ADDENDUM NO. 1

Project: ITB 26-4: Marine Park Wastewater Treatment Facility Aeration Basin Improvements

Date: January 21, 2026

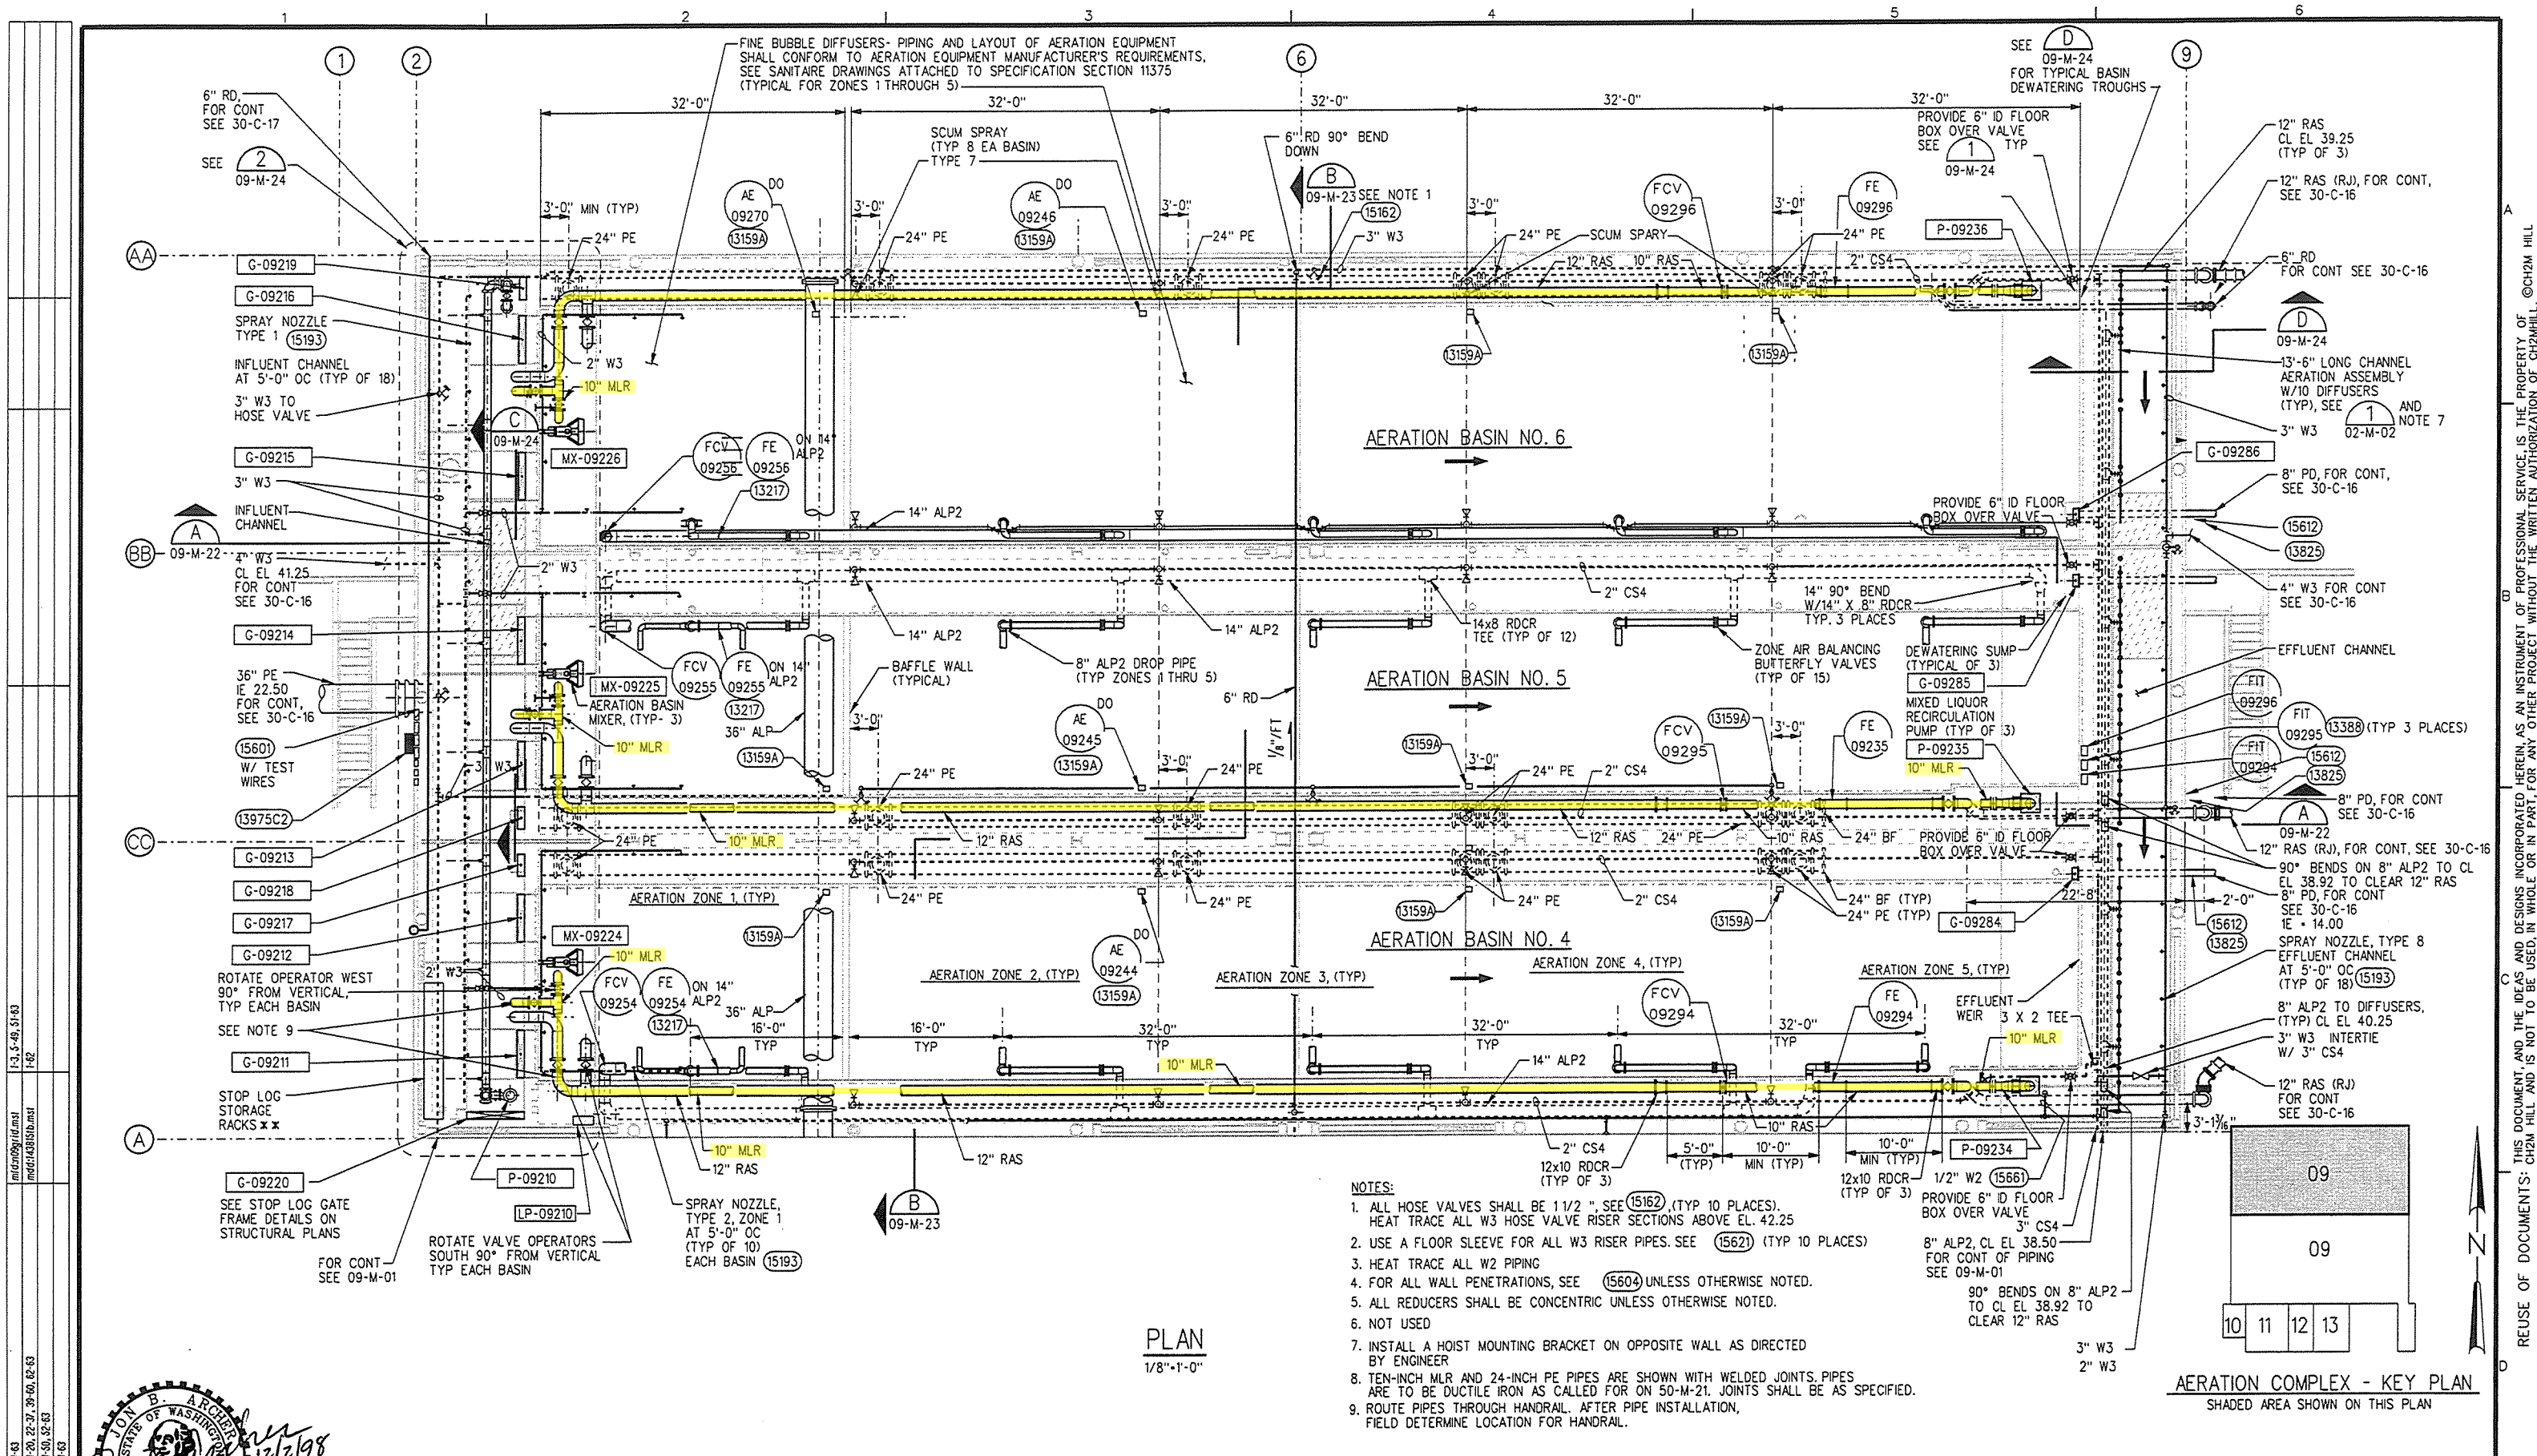
Q2: On drawings 09-E-1101 and 09-E-1102, sheet keynote no. 2 says "install conduit runs under walkways". Is it acceptable to run the new conduit above the walkways along the railing, similar to some existing conduit?

A2: Yes. It is acceptable to run the conduit above the walkways, along and outside of the railing, as long as the conduit will not block or impact the access to any existing or new equipment and instrument.

AERATION BASINS 4, 5, & 6
Mechanical
SECTIONS

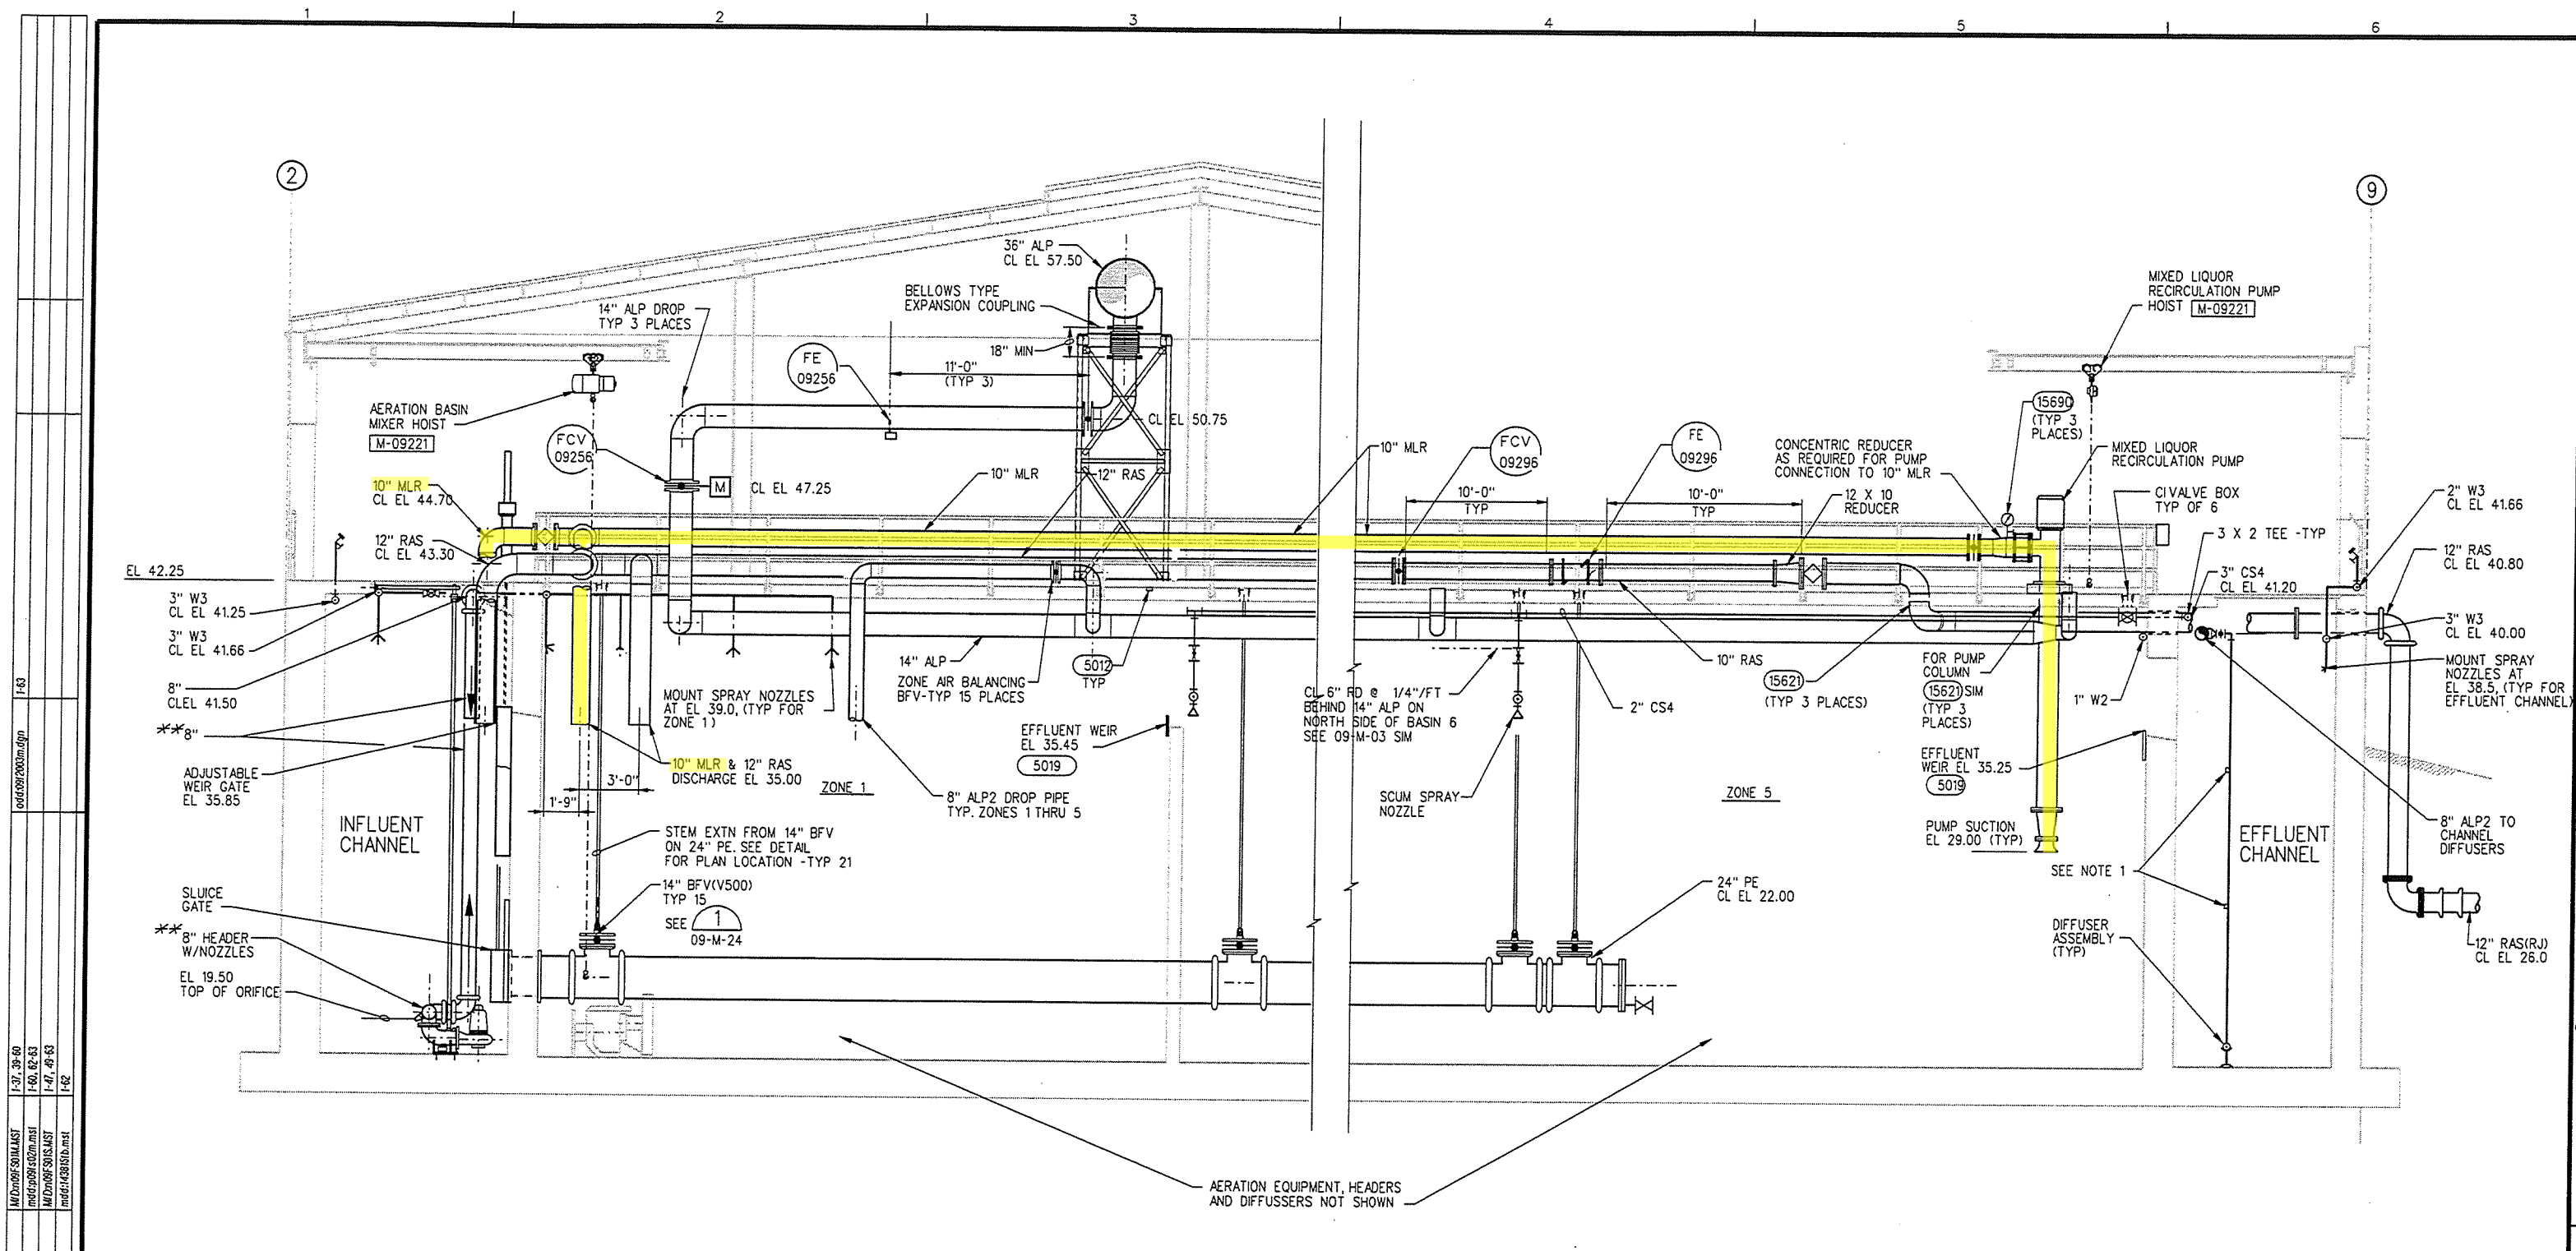
Q1: Could you please confirm the demolition extents for the MLR piping on the west end of basins 4, 5 and 6? Can sectional drawings be provided for this area?

A1: The MLR pipes for Aeration Basin No. 4, 5 and 6 are very similar to those in Aeration Basin No. 1, 2 and 3. Please see the attached as-built drawings for MLR in those aeration basins.
